CONDITIONS OF DRAFT PLAN OF SUBDIVISION APPROVAL

DRAFT PLAN OF SUBDIVISION FILE 19T-19V004 ('THE PLAN')

GB (VAUGHAN SEVEN) LIMITED PARTNERSHIP ('THE OWNER')

**PART OF LOT 7, REGISTERED PLAN 7977. PART OF LOT 5, CONCESSION 4,
CITY OF VAUGHAN**

DRAFT PLAN OF SUBDIVISION
PART OF LOT 7, REGISTERED PLAN 7977
CITY OF VAUGHAN
REGIONAL MUNICIPALITY OF YORK
SCALE 1:300

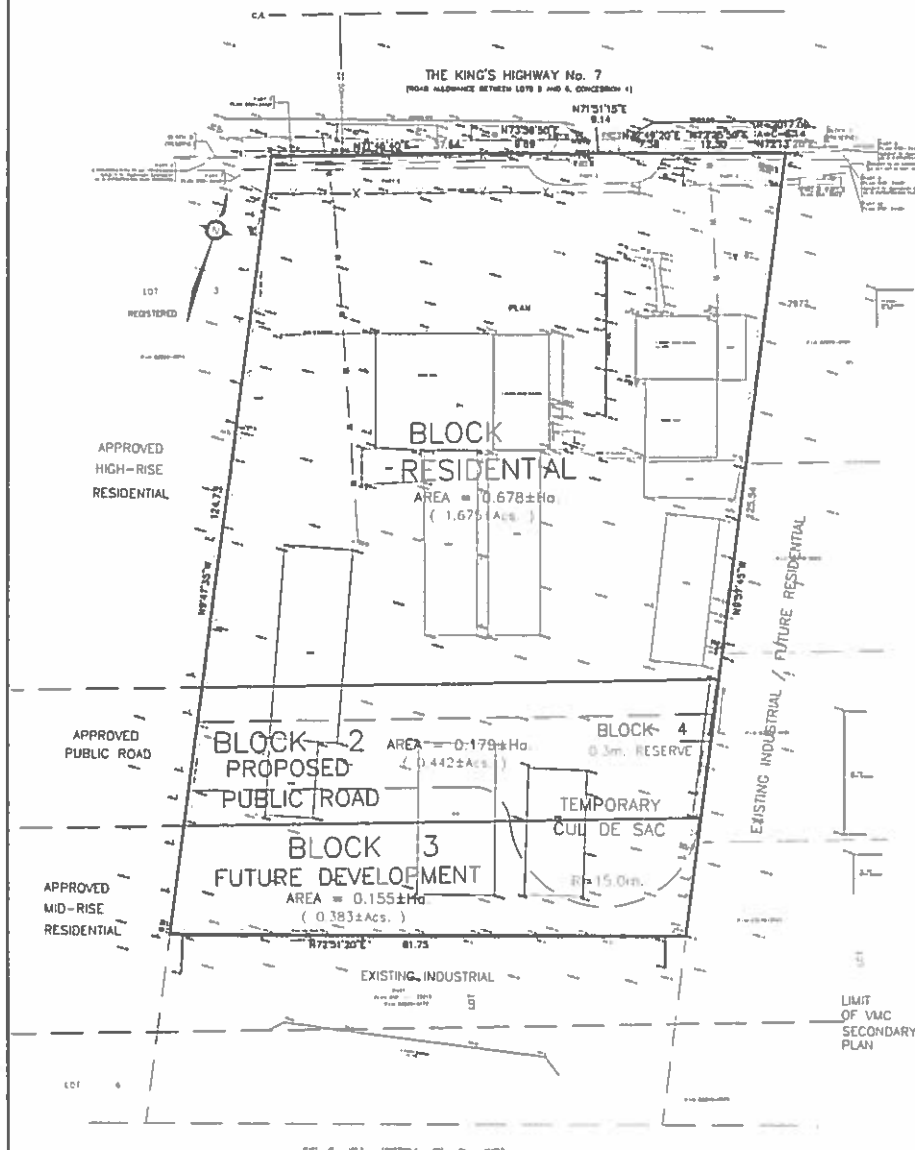
1. The final Plan shall relate to the Draft Plan of Subdivision, prepared by KLM Planning Partners Inc., Project No. P-3051, dated September 15, 2020, and surveyors certificate dated October 15, 2019 (the 'Plan') and be amended or redlined to:

- a) Appropriately label both the north-south private road which is subject to a public access easement within Block 1 and the east-west public road currently known as Block 2 with approved/assigned street names or as Street "A" and Street "B" respectively.
